TECHNICAL BULLETIN

[Issue No.] GOT-A-0051

[Title] Change to the Video/RGB Interface of the GT16 and GT15 Models

[Relevant Models] GOT1000 Series (GT16 Models: GT1695M, GT1685M, GT1675M, GT1665M
GT15 Models: GT1585V, GT1575V)

2. How to identify the temporary GOT

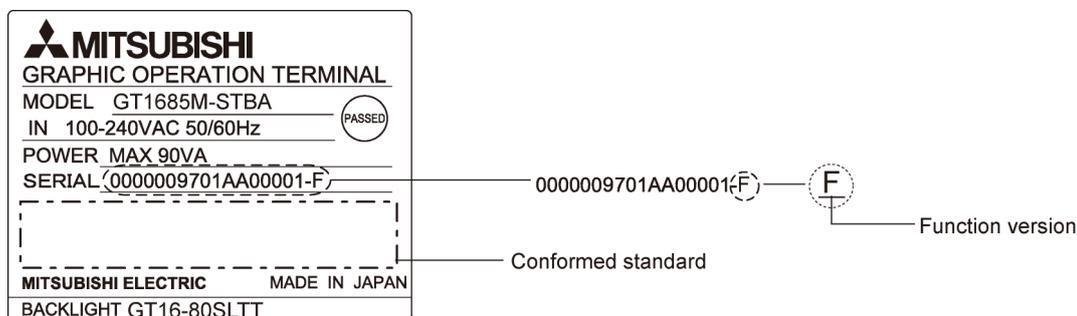
Function version F applies to the temporary GT16 model.

Function version E applies to the temporary GT15 model.

You can use the video/RGB interface of the target models excluding the above function versions.

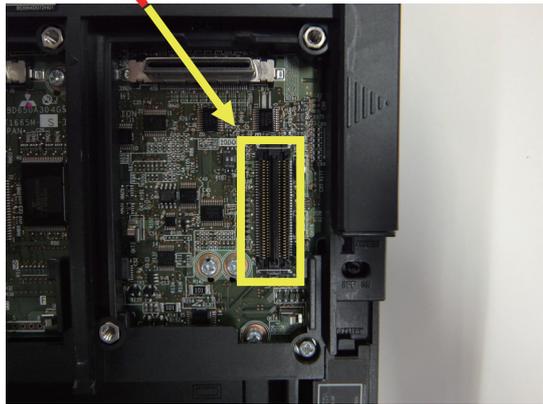
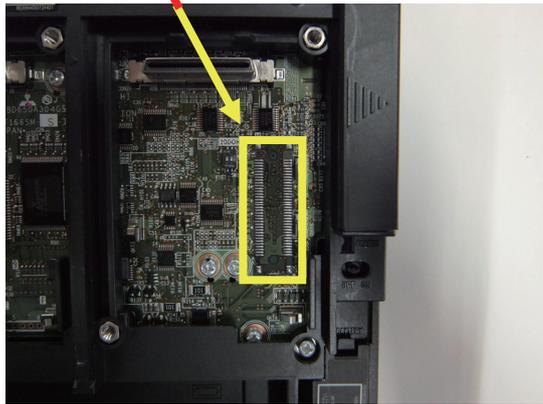
Since the temporary GOT does not have the connector of the video/RGB interface, you cannot mount the following option units.

Though you cannot use the functions requiring the above units, the other functions and the specifications do not differ between the temporary GOT and the normal GOT.

The video/RGB interface is located on the extension interface 2 side on the GOT rear face without the extension unit cover.

Normal GOT	Temporary GOT
Appearance	<p><u>With the connector</u> of the video/RGB interface</p> 	<p><u>Without the connector</u> of the video/RGB interface</p>
